## Barracuda - BC 630 Upgrade

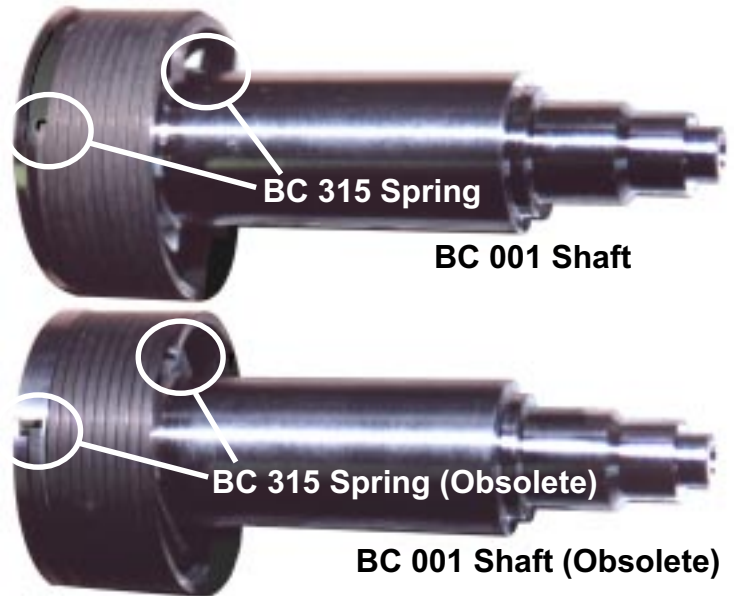
When re-assembling the **Barracuda** internal parts, after overhaul, a minor positioning error can result in failure of the centrifugal rotation speed control. If the **BC 315 Spring** comes loose at either end, it can damage the **BC 001 Shaft** and **BC 230 Sleeve**. It can also break in the process. Changes made include new springs with 90° bend at each end, so that they fit securely into a new hole/slot in the shaft and weights. The new design parts are installed in serial number 920 and higher. The new **BC 630 Upgrade Kit** fixes the problem in all old-design **Barracudas**. Included in the kit are a new shaft, weight set, spring, and bronze sleeve.
